**SHINE TECHNOLOGIES, LLC APPLICATION FOR AN OPERATING LICENSE SUPPLEMENT NO. 15  
SUBMITTAL OF THE PHASED STARTUP OPERATIONS APPLICATION SUPPLEMENT**

**SHINE PHASED STARTUP OPERATIONS APPLICATION SUPPLEMENT  
(PUBLIC VERSION)**

**Figure 6a2.2-1 – Tritium Confinement Boundary  
(Sheet 1 of 2)**

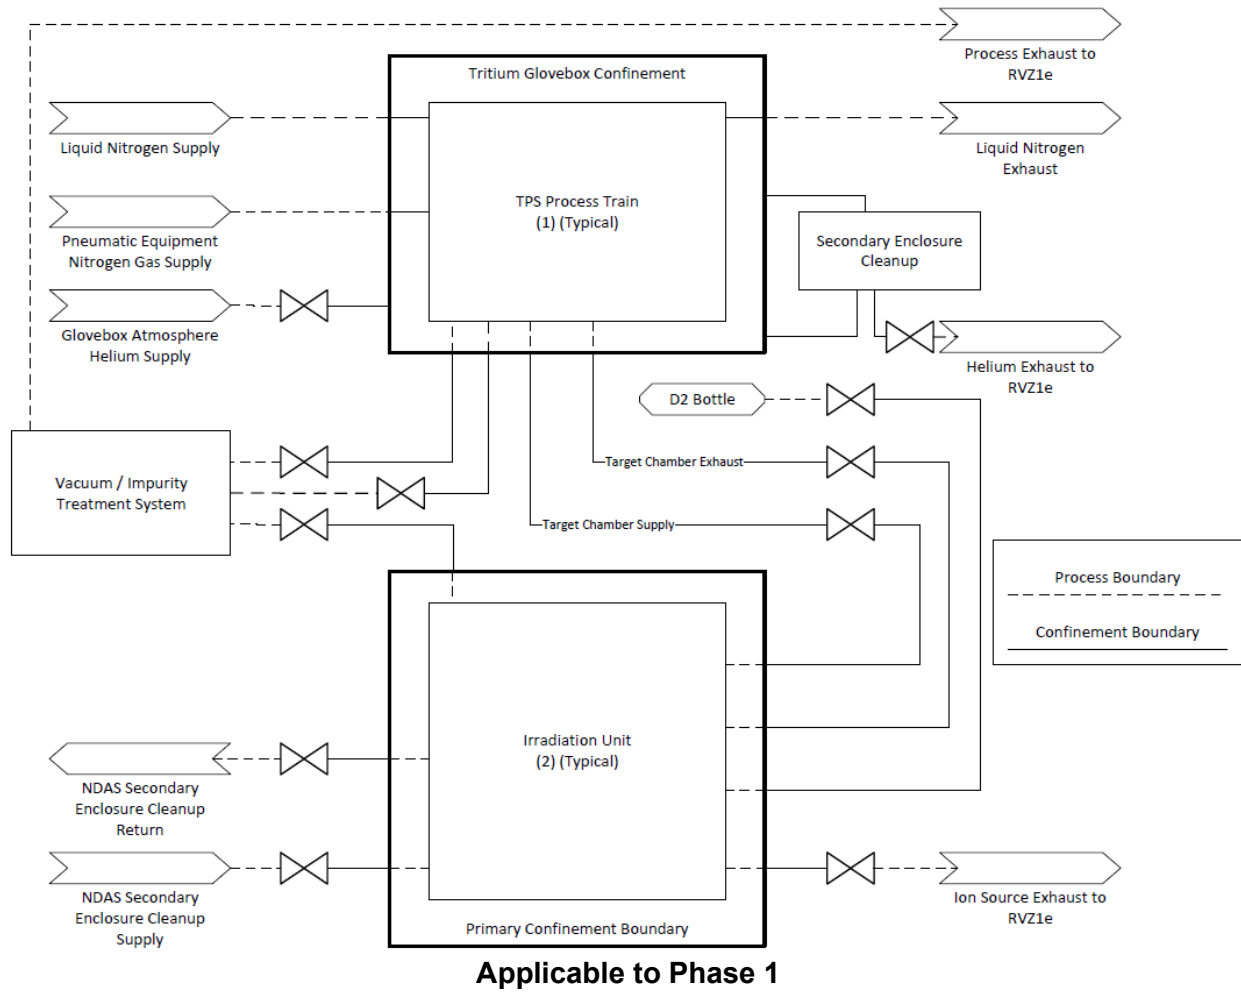
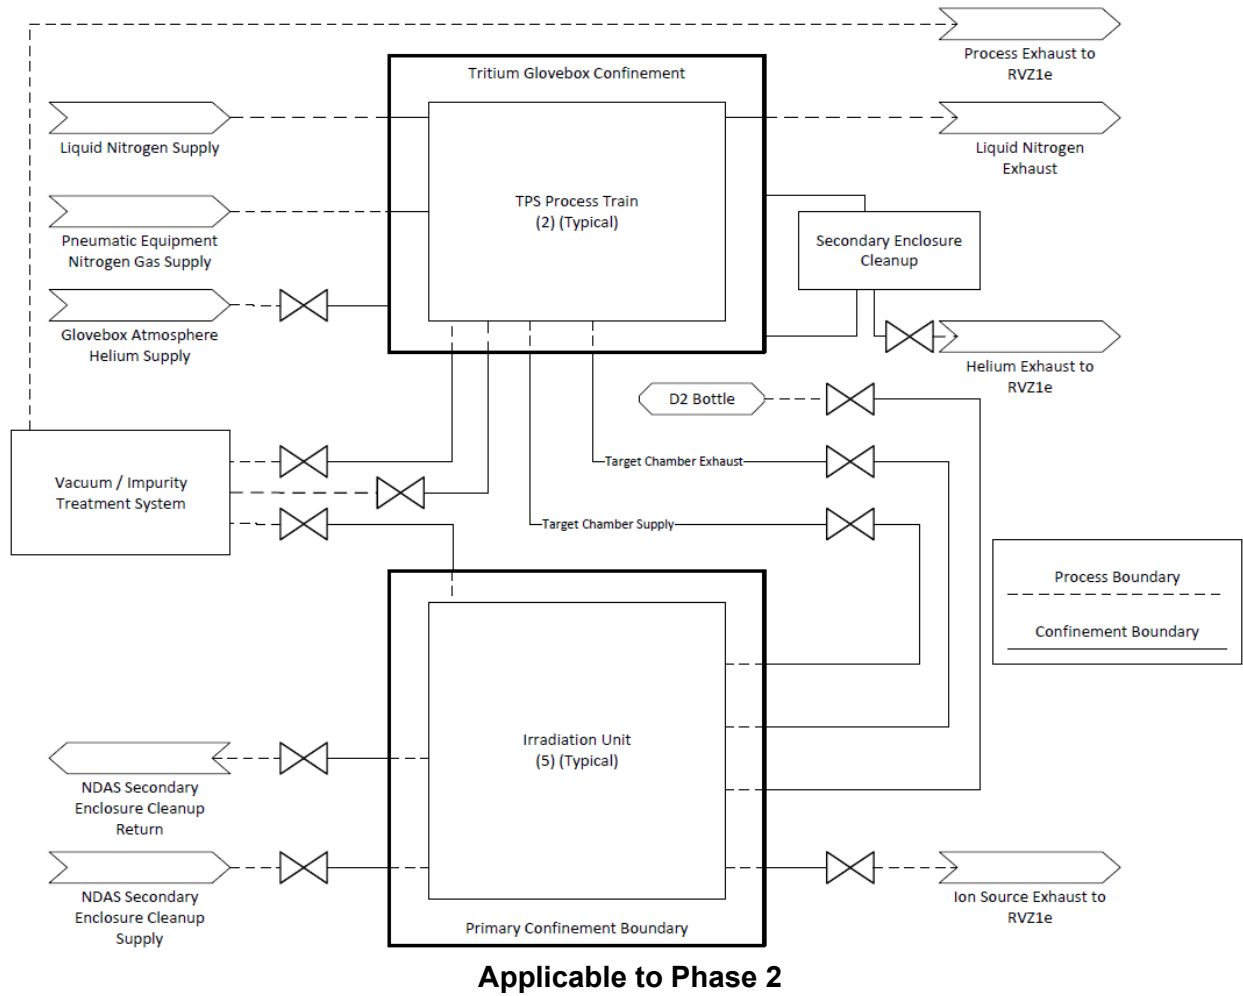
Figure 6a2.2-2 of the FSAR is not impacted by the phased startup operations with the exception of the number of TPS process trains and irradiation units present in each phase. Figure 6a2.2-1 provides an update to Figure 6a2.2-2 of the FSAR to reflect the number of TPS trains and IUs in operation during Phase 1 and Phase 2.

Figure 6b.2-1 – Supercell Confinement Boundary

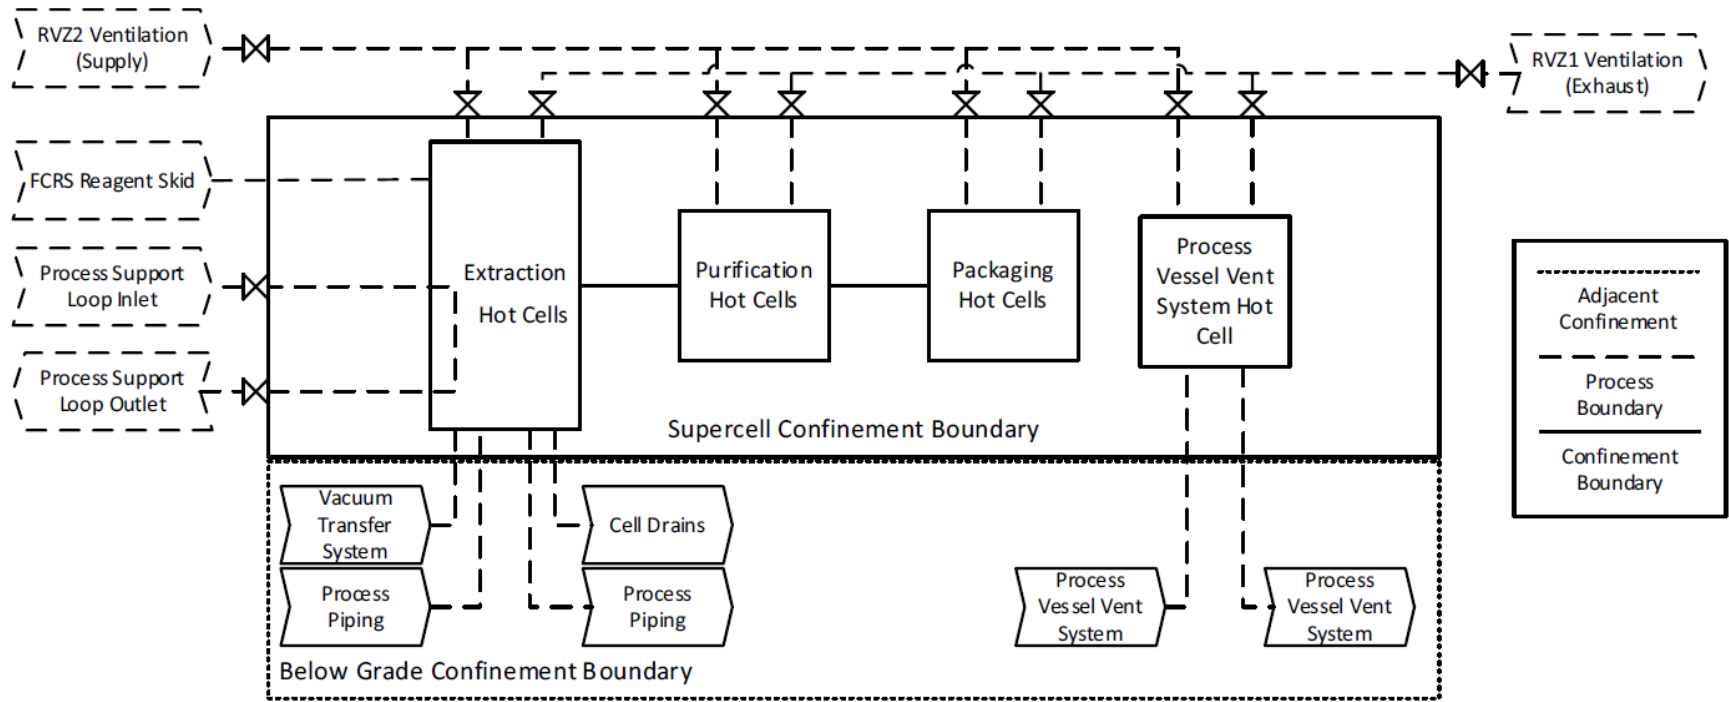
Figure 6b.2-1 provides a block diagram of the supercell confinement boundary applicable to Phase 1, 2, and 3 operations.

Figure 6b.3-1 – Radioactive Liquid Waste System Overview

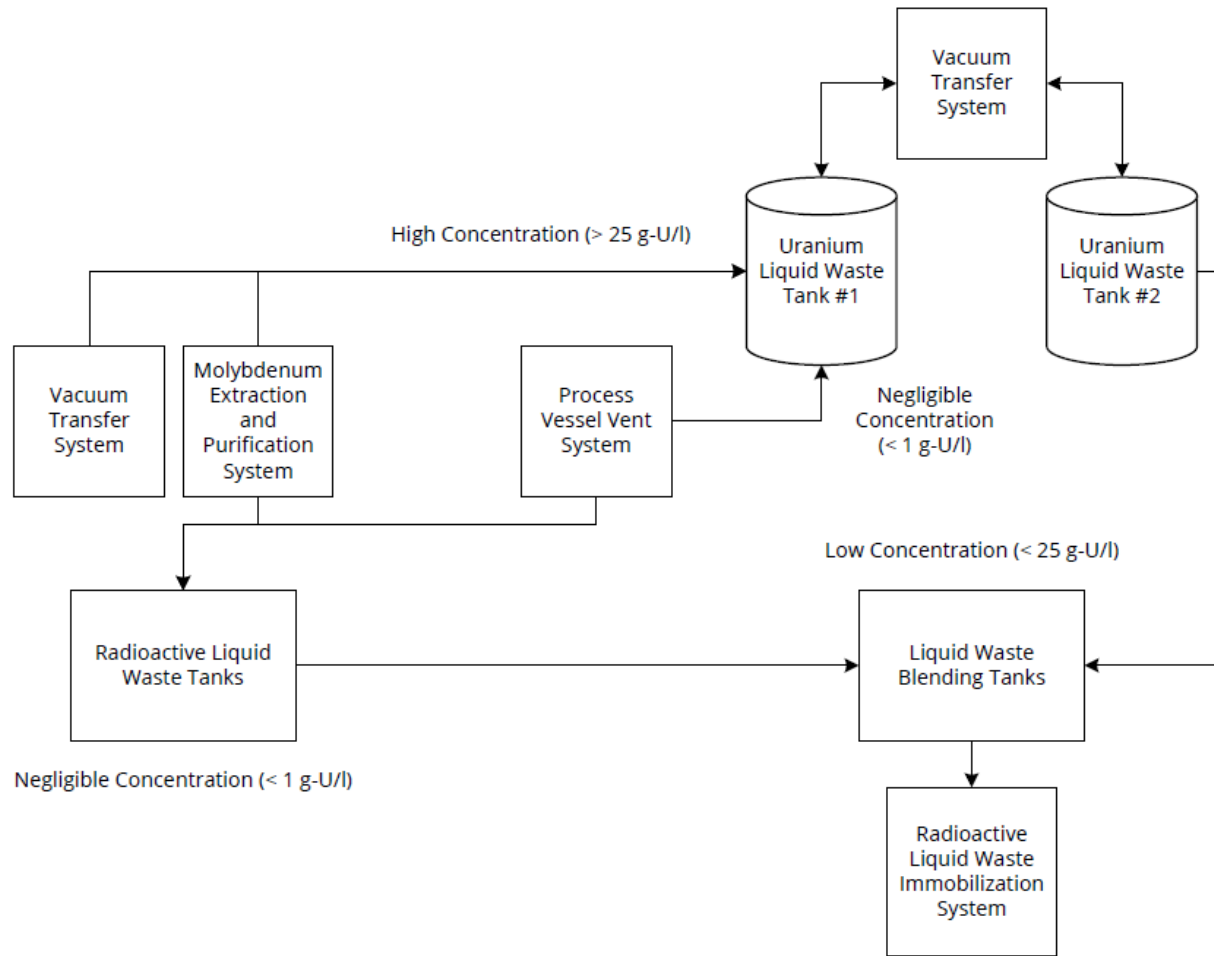
To reflect installation of the IXP system to support Phase 4 operation, Figures 6b.3-1, 6b.3-2, and 6b.3-3 provide system overviews of the radioactive liquid waste storage (RLWS) system, the molybdenum extraction and purification system (MEPS), and the radioactive drain system (RDS), respectively, in Phases 1, 2, and 3. The Phase 1, 2, and 3 system overviews provided in Figures 6b.3-1, 6b.3-2, and 6b.3-3 provide configuration updates to the system overviews
